Subject: **Docket Nos. 50-361 and 50-362
Response to Request for Additional Information on the Proposed
Amendment for Loss of Voltage Signal (LOVS) Relay Replacement,
Proposed Change Number (PCN) 577 (TAC Nos. MD5112 and MD5113)
San Onofre Nuclear Generating Station, Units 2 and 3**

NRC QUESTION

SCE RESPONSE

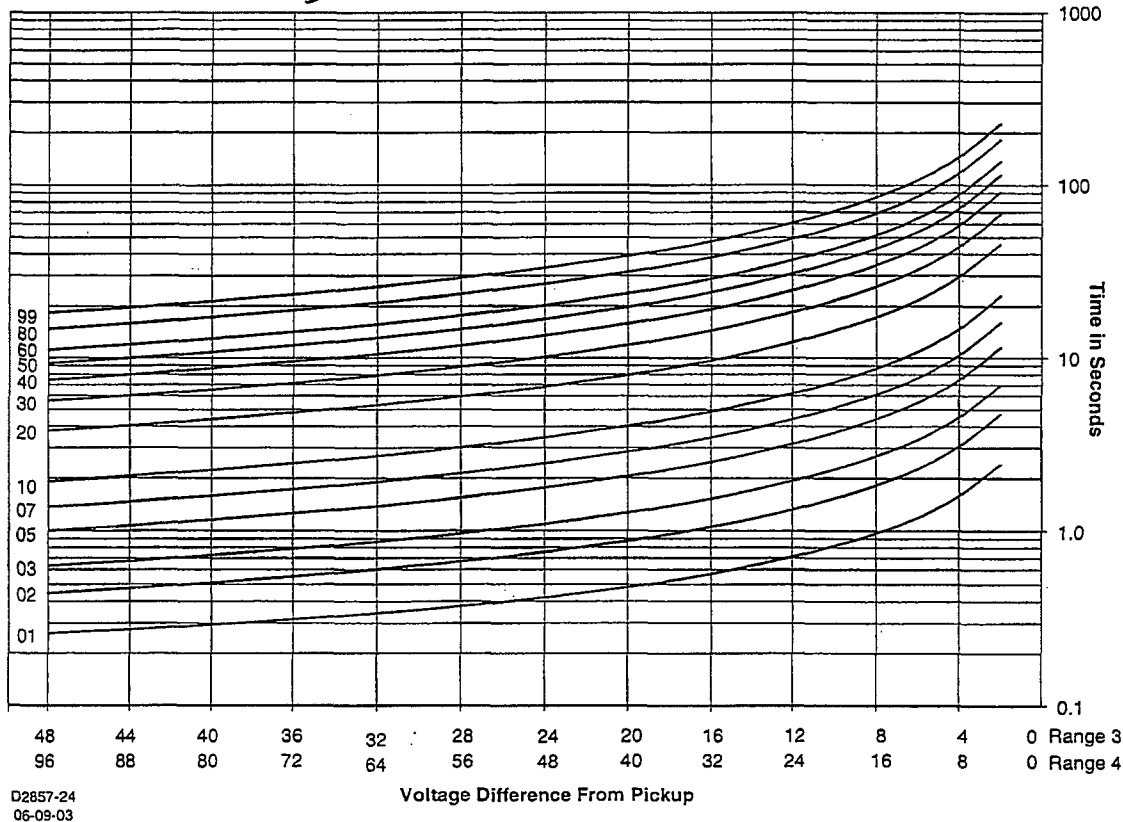
In the LAR dated March 30, 2007, the licensee stated the following on Page 1 of Enclosure 2: "The 115.5 V initial voltage (110% of the 105 V setpoint) to 57 V minimum voltage is selected based on the available manufacturer's relay curves which provided the specific time at 57 V when voltage is dropped from 115.5 V." The Technical Specification change request also states for the requested time delay "(voltage change from 115.5 V to 57.0 V)".

Staff reviewers could not confirm the above from the manufacturer's catalog for the BE1-27 relay. The curves provided for the relay provide the operating time in terms of voltage difference from the pickup setting (nominal 105.0 V) and the time dial.

Applicable inverse timing characteristic curves for the loss of voltage relay are shown in the manufacturer's enclosed Figure 3-2 using range 3. The horizontal scale of Figure 3-2 (range 3) shows voltage difference (0 to 48 volts) from the relay pickup setting. The manufacturer's catalog for the model BE1-27 relay describes that the inverse time curves were generated with pre-fault voltages at 10% higher than pickup for the model 27 relay curves (page 1-5, enclosed).

Figure 3-2 therefore shows that a relay with a voltage tap setting of 105 V will operate as follows:

- 1) When the system voltage drops from a pre-fault voltage of 115.5 V (110% of relay pickup voltage 105 V) to 105 V (0 V difference from the relay pickup setting), the relay will take more than 4 seconds to operate if the time dial is set at #7, or more than 10 seconds for time dial setting at #20.
- 2) When the system voltage drops from a pre-fault voltage of 115.5 V (110% of relay pickup voltage 105 V) to 57 V ($57\text{ V} = 105\text{ V} - 48\text{ V}$), the relay will operate within 0.4 seconds if time dial is set at #7 or more than 1.0 second for time dial setting at #20.

Figure 3-2 does not give relay operating times when the system voltage drops from 110% of the relay pickup setting to zero volts. The manufacturer does not provide relay operating times for this case because they do not have official test data.

Therefore, it was determined that the allowable time delay in the proposed Technical Specification (0.69 to 1.0 second, inclusive) should be measured when the voltage changes from 115.5 V (pre-fault voltage = 110% of LOV relay pickup setting) to 57 V (105 V - 48 V), which is the lowest voltage shown in the Figure 3-2.
